# ADDENDUM

ADDENDUM NO.: 01  
PROJECT NAME: DUNNE TECHNOLOGY ACADEMY MODERNIZATION – SCOPE B  
PROJECT NO.: 05440  
CONTRACT NO.: C1566a  
DATE OF ISSUE: May 1, 2015

## NOTICE OF CHANGES, MODIFICATIONS, OR CLARIFICATIONS TO CONTRACT DOCUMENTS

**Figure 5 - Work Limits: June 29, 2015 to August 21, 2015**

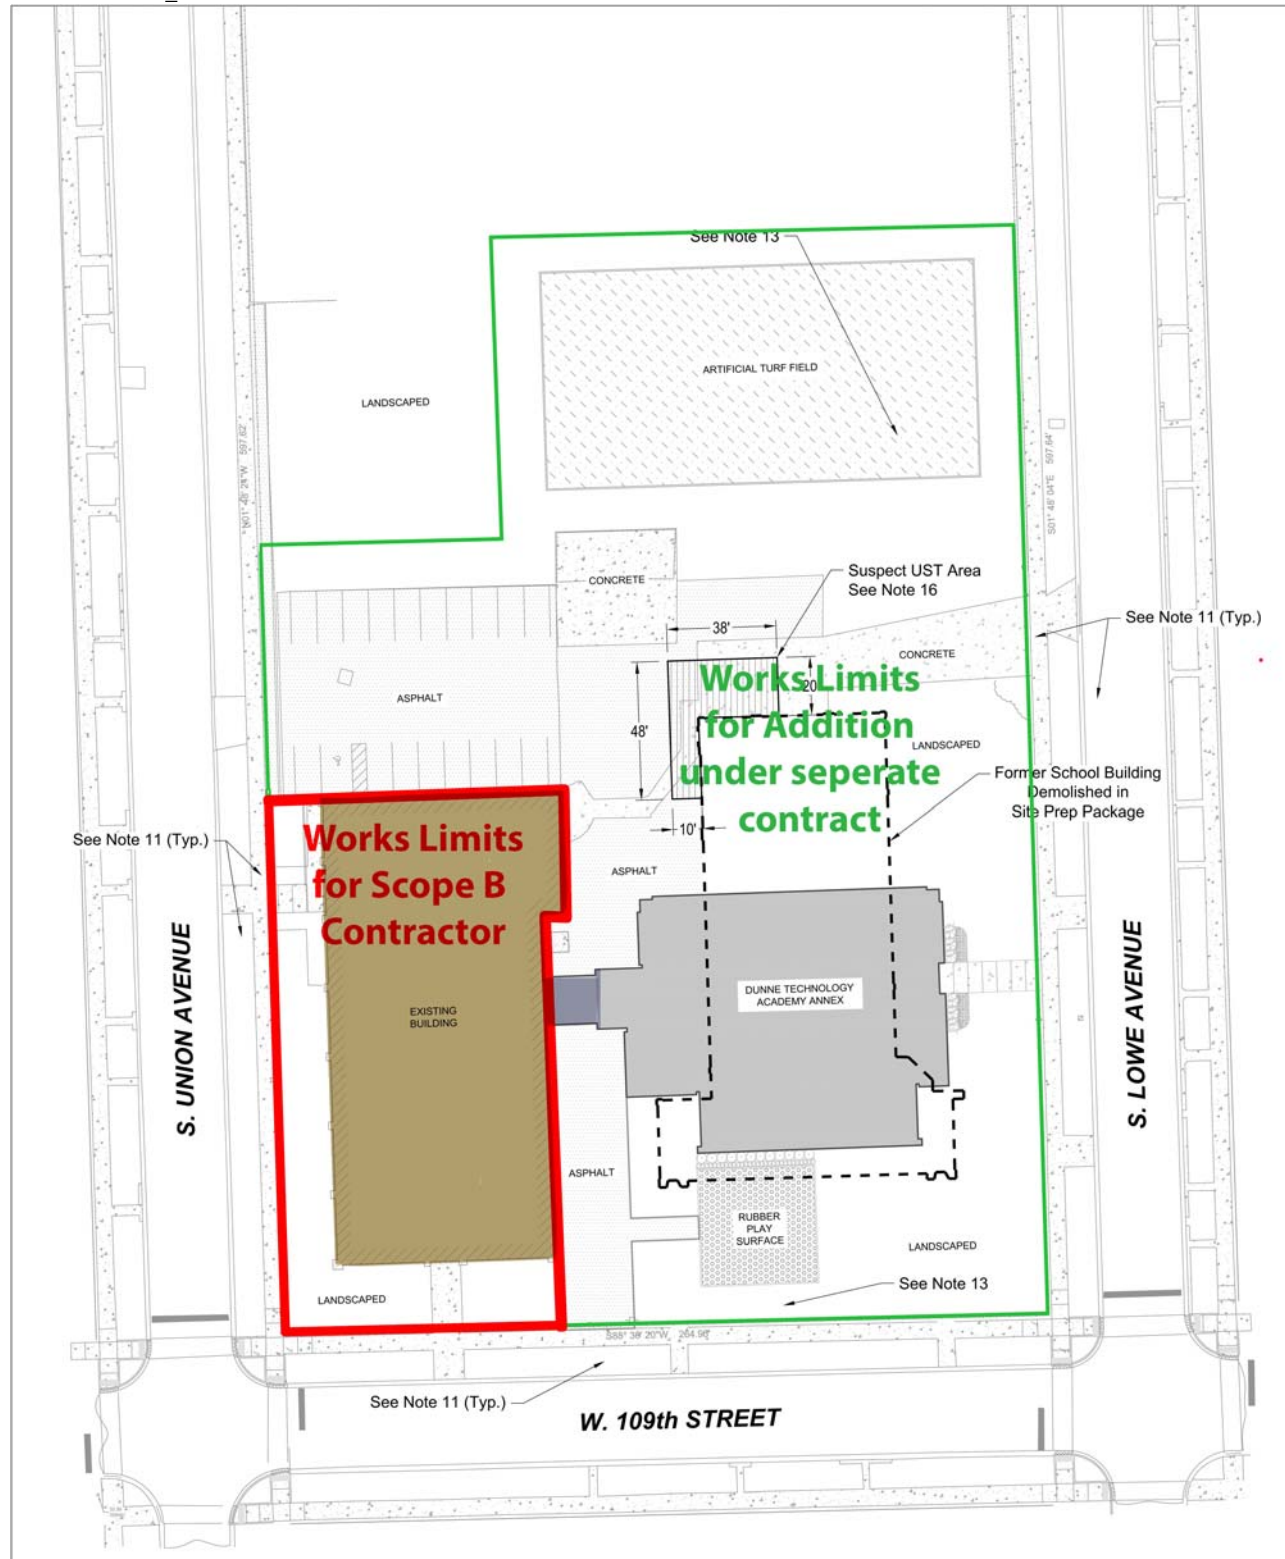
5. Specification 01 14 11A – SITE UTILIZATION PLAN – PHASING DIAGRAMS
  - a) Replace section in its entirety with revised section attached.
